Subject: AP1000 Response to Request for Additional Information (SRP 3)

A response is provided for RAI-SRP3.7.1-SEB1-15 R2.

AP1000 TECHNICAL REPORT REVIEW

RAI Response Number: RAI-SRP3.7.1-SEB1-15
Revision: 2

Figure RAI-SRP3.7.1-SEB1-15-3 – East-West 2D SASSI Model with Adjacent Buildings

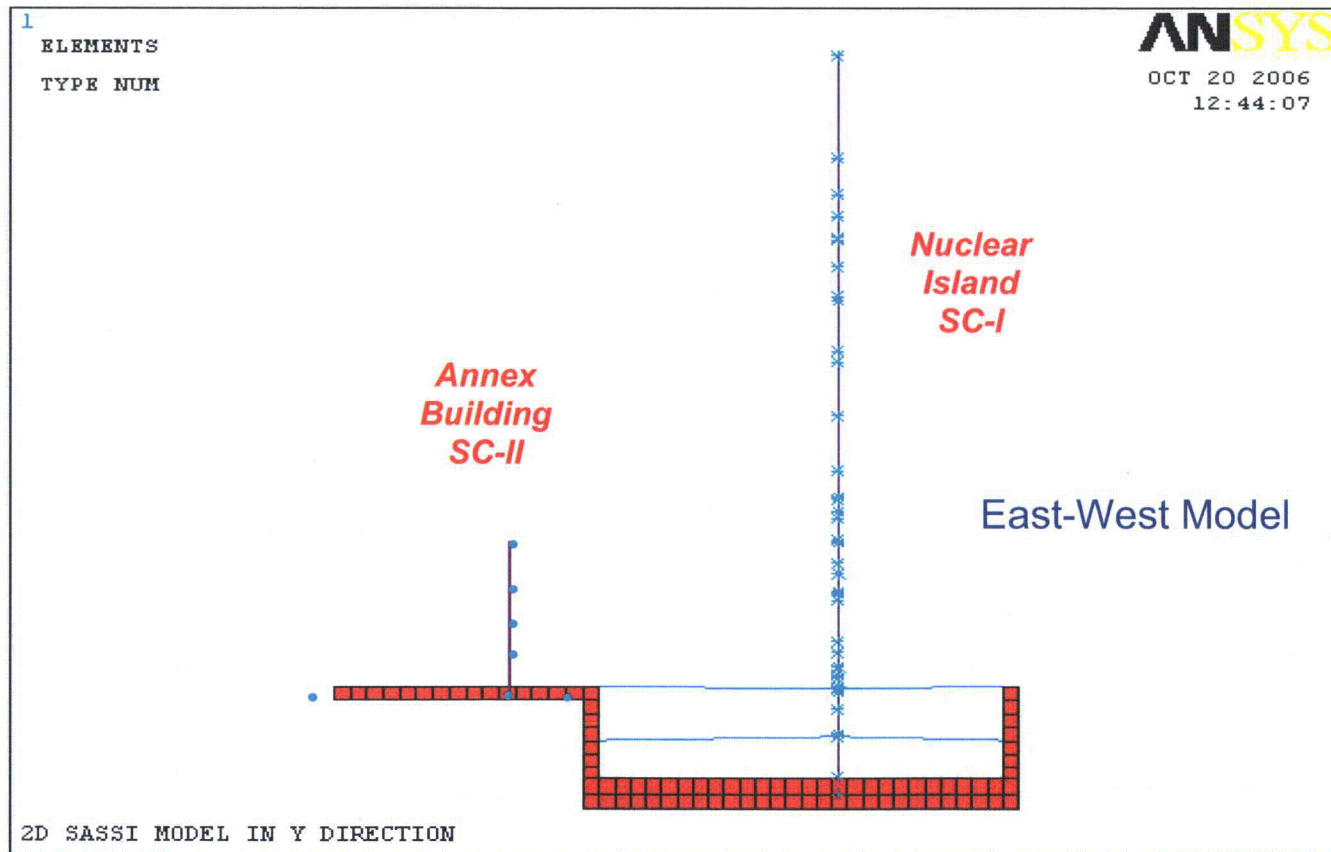
3) Westinghouse will submit revised RAI-SRP3.7.1.-SEB1-015 (including a DCD modification) to address application of 2D vs. 3D SASSI, how 2D & 3D will be used for building responses, how analyses will be done for various soil sites using CSDRS Ground motion input, evaluation of building response at hard rock sites using backfill with HRHF ground motion.

- 3) The seismic analyses performed for the adjacent seismic Category II structures will be a simulated 3D analysis. The seismic analyses will be performed primarily using 2D SASSI models. To properly account for 3D effects, the response from 2D and 3D SASSI analyses of the seismic Category II buildings on rigid foundations will be compared and a 3D effect factor will be developed from this comparison. Three soil cases [Upper Bound Soft to Medium (UBSM), Soft to Medium (SM), and Soft Soil (SS)] will be used to determine the 3D factor. Shown in Figures RAI-SRP3.7.1-SEB1-15-3 and RAI-SRP3.7.1-SEB1-15-4 are the 2D SASSI models with adjacent building structures. The seismic Category II buildings are modeled as stick models. The 3D model with adjacent structures is shown in Figure RAI-SRP3.7.1-SEB1-15-5.
